ORIGINATION FORM

Proposed Revisions to a Standard Plans Index
(Please provide all information — Incomplete forms will be returned)

Index Number: 102-200

Index Title: Temporary ACROW 300 Series Bridge General
Notes & Details

INDEX
102-200

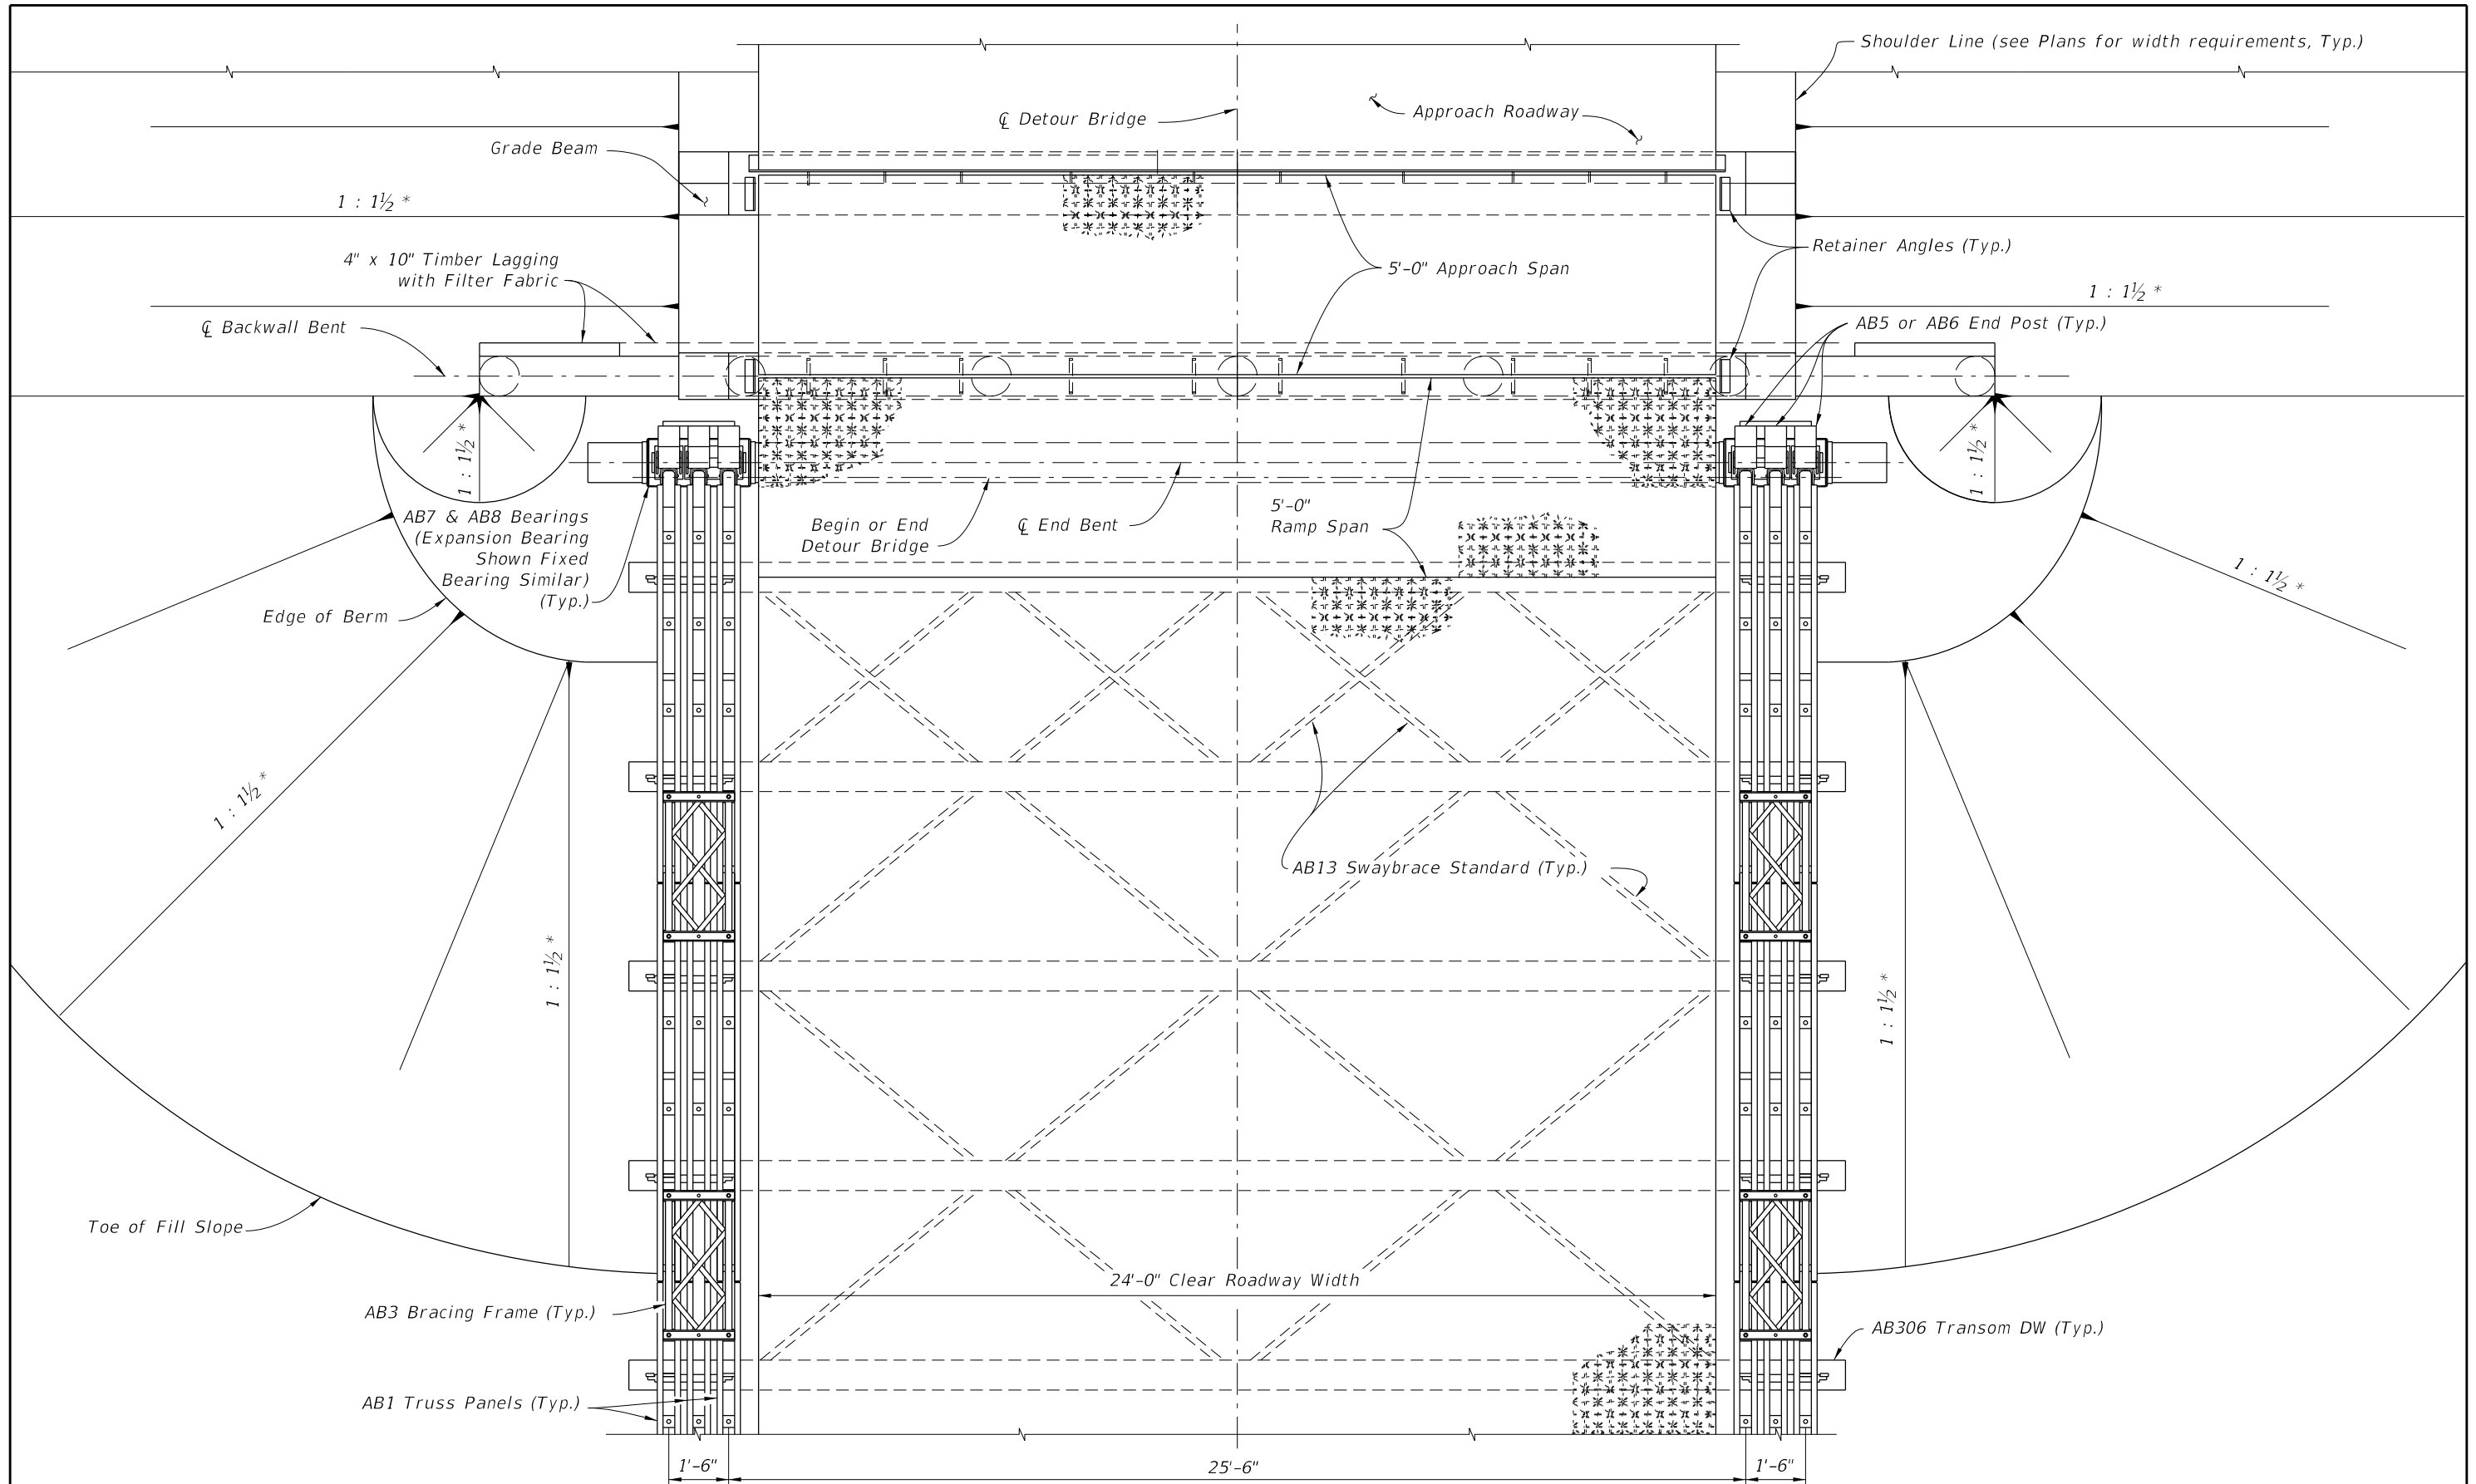
Changed Title to Include 300 Series
